Bug-8 Report

Group-8

1. **Failing Test name** – Data cache write miss test with no free block by using MESI protocol

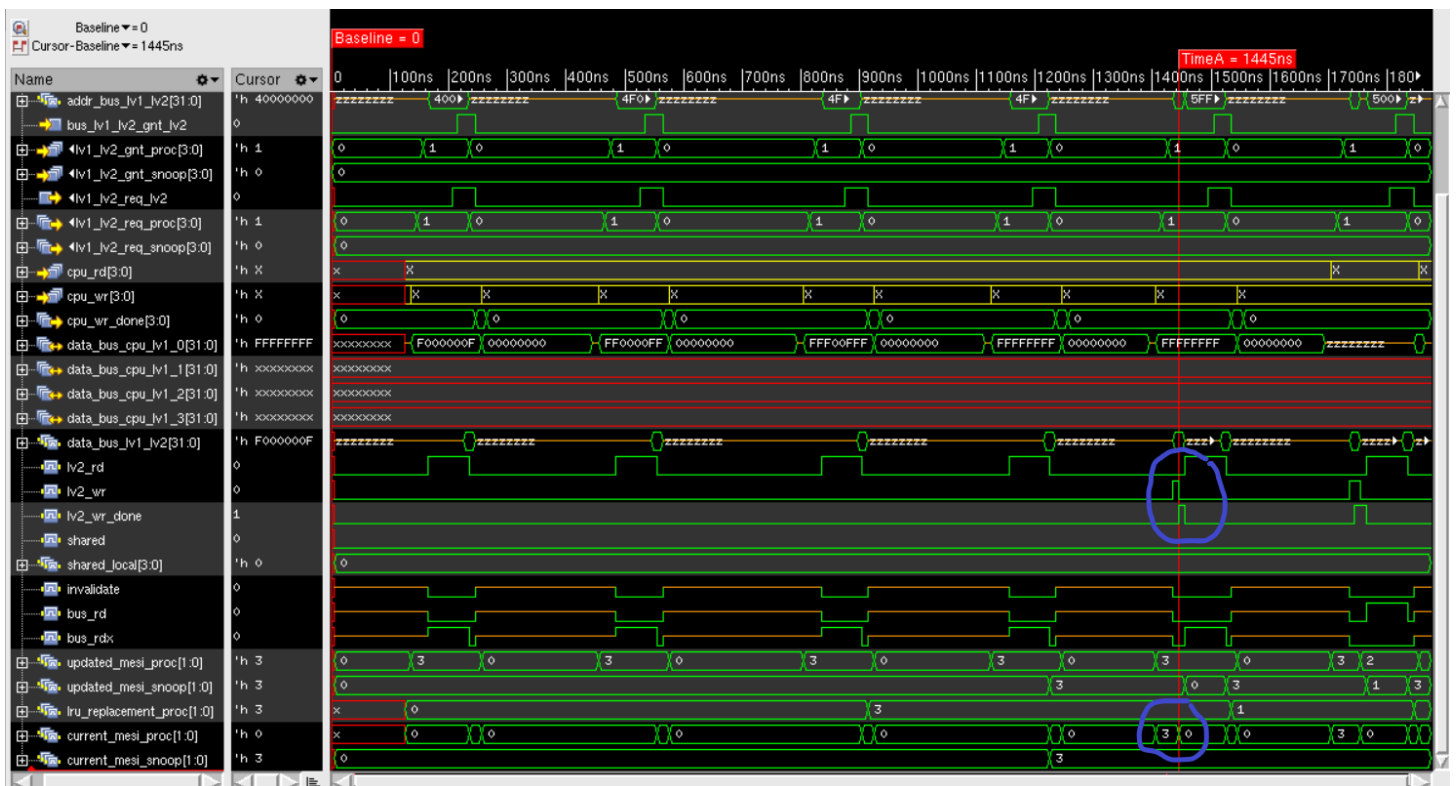
As per HAS document for write miss with block replacement operation, when the MESI state is in 'M' for the block to be replaced then we should make bus_lv1_lv2_gnt_proc high and address of replacement block is loaded into addr_bus_lv1_lv2. Dirty data is loaded into data_bus_lv1_lv2 then lv2_wr is made high to update the value in lv2. Once lv2_wr_done is made high then MESI state of block to be replaced is set to 'I'. Later, steps similar to write miss operation with free block available.

In the above waveform the current_mesi_proc[1:0] is changed to 0 (which is 'I') even though lv2_wr_done was not asserted.

5. **Erroneous RTL file name** – main_func_lv1_dl.sv

6. **Lines of RTL file responsible for the bug** Line 281: if (lv2_wr) begin

7. Corrected RTL code Line 281: if (lv2_wr_done) begin
